NEWMAR CORPORATION WARRANTY DEPARTMENT

TECHNICAL SERVICE BULLETIN									
DATE ISSUED MODEL YEA		EAR(S) AFFECTED		Model(s) Affected			TSB#		
8/26/92	1993			ALL			59		
Brand						TYPE			
All American Star Kountry Star			Dut	ch Star 🛚	All	ТТП	FW □		
NewAire □ Mountain Aire □ Kountry Aire □				don Aire□	САП	D₽□	DB 🗖		
☐ Air Conditioning &	☐ Electrical Components								
☐ Appliances & Accessories			☐ Exterior Components						
☐ Cabinets & Furniture				☐ Interior Components					
☐ Chassis Components				☐ Plumbing & Bath Components					
Construction Components				☐ Windows, Awnings, Vents, & Doors					
DESCRIPTION OF PROBLEM									
		RECOMMENDE							
Newmar has changed it on it. Please contact No			will h	nelp to show t	he operation a	nd elect	crical hook up

EMERGENCY EXTENSION AND RETRACTION OF THE RACK & PINION S/O ROOM

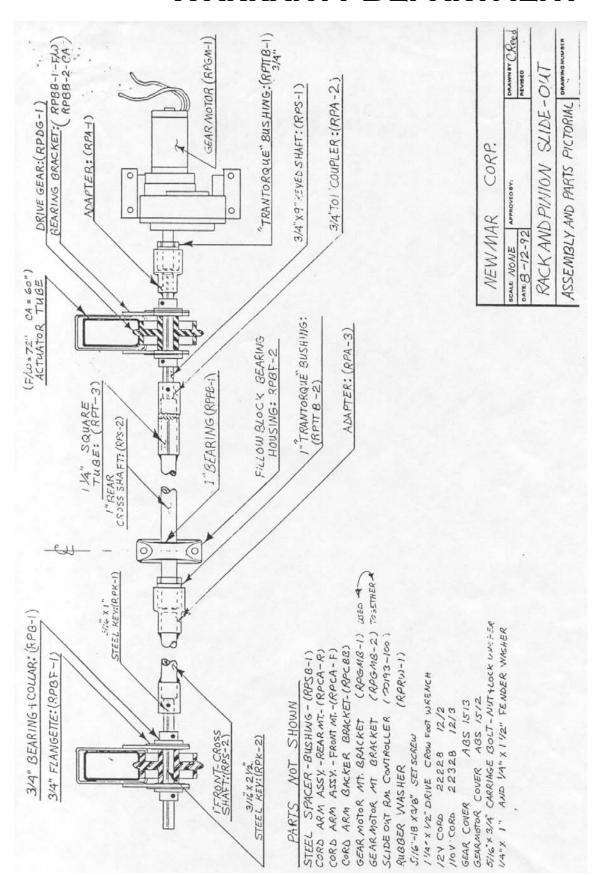
- 1. Access must be gained to the "Trantorque" bushing coupling at the output end of the s/o gearmotor.
- 2. Using the factory supplied 1/2" drive 1 1/4" open end crows foot wrench and a user supplied 1/2" drive ratchet wrench, loosen the 1 1/4" nut. (Approx 1 1/2 turns. The nut is std. R.H. thread. After the initial release the nut will turn freely for a partial turn then will release again as you continue to turn the wrench. This second release is required to loosen the "Trantorque" from the shaft.
- 3. The s/o room may now be moved by 2 methods.

A. With the proper amount of help, (2 people min) the room can be pushed in either direction the full length of its travel.

B. The 1 1/4" crowfoot wrench and 1/2" drive ratchet wrench can be used on the short 1 1/4" square section of the cross shaft. One person is capable of moving the s/o room using this method.

The "Trantorque" must be re-rightened to re-couple the gearmotor before moving the coach (to hold the s/o room).
